**MEMORANDUM**

**TO:** City of Northville Planning Commission

**DATE:** April 26, 2022

**RE:** Discussion on Mobility Questions with Representatives of Mobility Network, River Task Force, Sustainability Task Force, Dan Burden (Walkability Consultant), City Manager, City Engineer, and City Planner

**5. Angled parking on Cady St.**

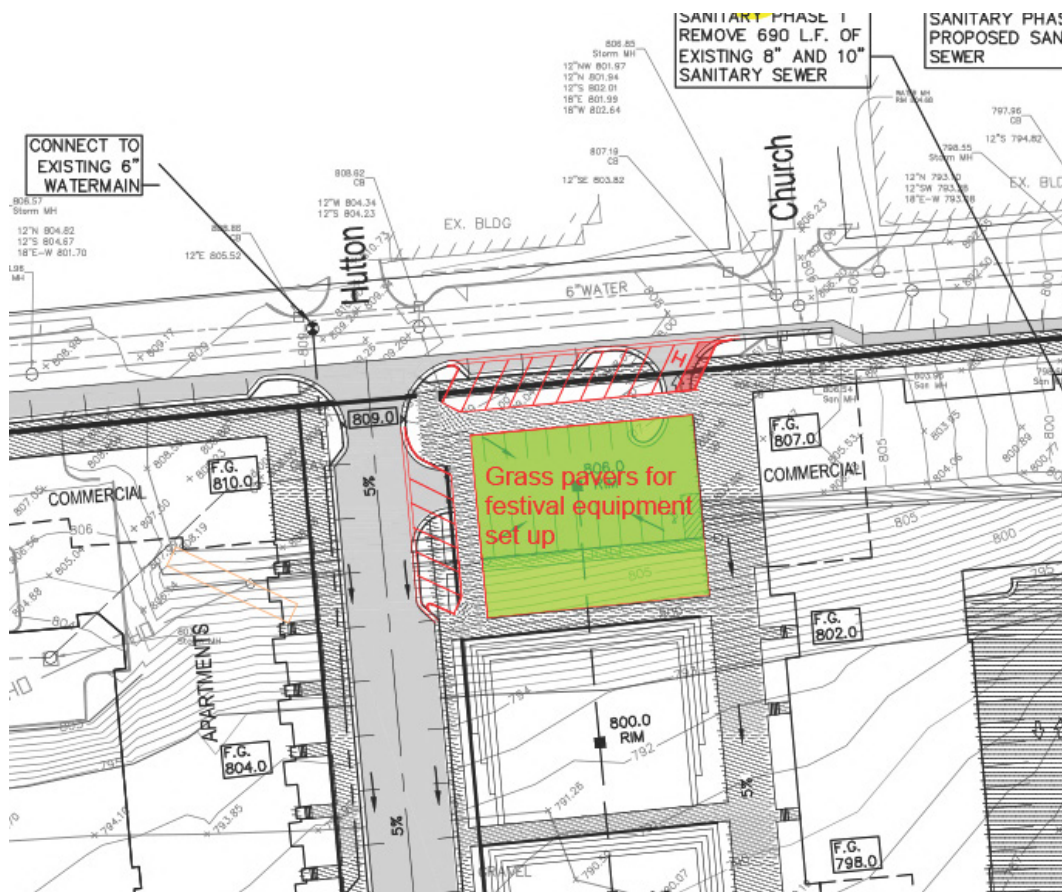
Recommendation: Leave parking along Cady St. as parallel parking. Another possibility discussed was whether angled parking could be configured along Cady St. to see if there are any benefits to this change (i.e., does this configuration generate significantly more parking spaces than parallel spaces?). The discussion determined that integrating angled parking along *one side* of Cady St. would probably require a 60-65-foot wide right-of-way; moving the buildings back so there is enough room for wide sidewalks; and the use of 60-degree "back-in" angled spaces to accommodate safe bicycle use of the travel lanes. Having angled parking along both sides of Cady would require a right-of-way width of at least 70 feet.

Clarification: The group thought angled parking did not fit into the present plan without moving the buildings and increasing the right-of-way width. It was stated that the current proposal supplies approximately 40 more parking spaces than required over the entire project. The apartments/ condominiums are slightly under parked compared to requirements, but residents of these buildings couldn't use on-street parking overnight so

extra spaces along Cady St. would only serve day-time users. The degree of change to the site design required to include angled parking was not justified by parking space count.

We did all agree that parallel parking along Cady was acceptable. Under "clarification," it states the group thought either option would work. The only person who thought angle parking along Cady Street would work was Dan Burden. Please do not say the group in whole thought it was okay.
